**SB-GA8-2011-75**

## Service Bulletin

Inspection of the upper tailplane gap strip LH/RH

**Figure 1: Horizontal Stabiliser connects to Fin Assembly**

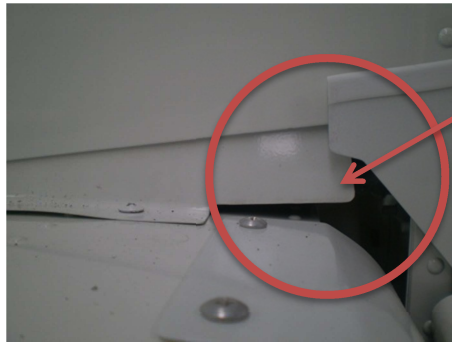
1. Turn the trim control to full nose up (stabiliser L/E down) position (fig. 1).

**Figure 2: Rudder Spar location**

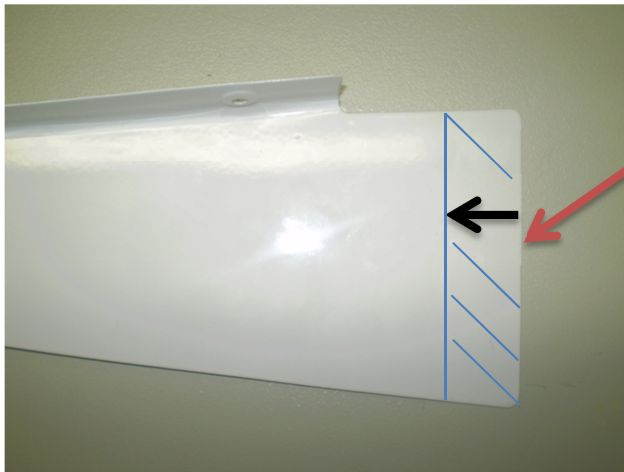
2. Check that the forward edge of the fairing does not contact the fin front spar assembly (fig. 2).
3. If there is any interference between the Upper LH/RH Fairing and fin front spar assembly, trim the edge of the fairing such that it does not contact with the assembly (fig. 3). And contact GA Customer support providing them with A/C Serial Number.
4. Refinish the paint over any bare metal.

Inspect this area (nose down – horizontal stabiliser position) to check the fairing does not interfere with the Fin front spar assembly – GA8-553011-19.

Trim this edge just enough so that it does not interfere with installation, radii the corners and refinish the paint over any bare metal.
